MIL-T-0012756B(EL)
Amendment 1

TEST SET, BATTERY
(BATTERY TESTER TS-183()/U)

This amendment forms a part of Military Specifications MIL-T-0012756B(EL) dated 31 December 1969.

FIGURE 1

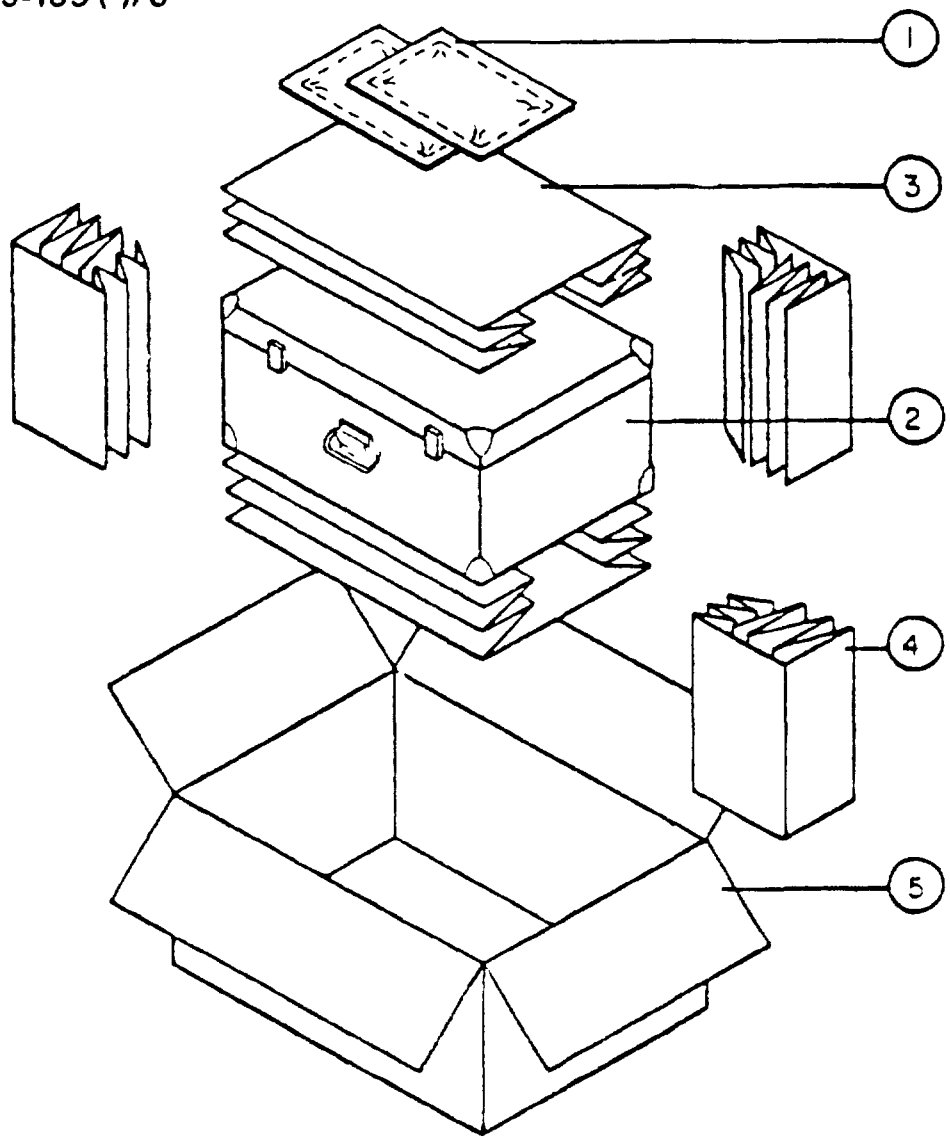
5.1.1.4 Unit packaging. Each Test Set, Battery TS-183( )/U shall be individually packaged in accordance with items 1 through 5 of Table VI and Figure 1.

Add Figure 1
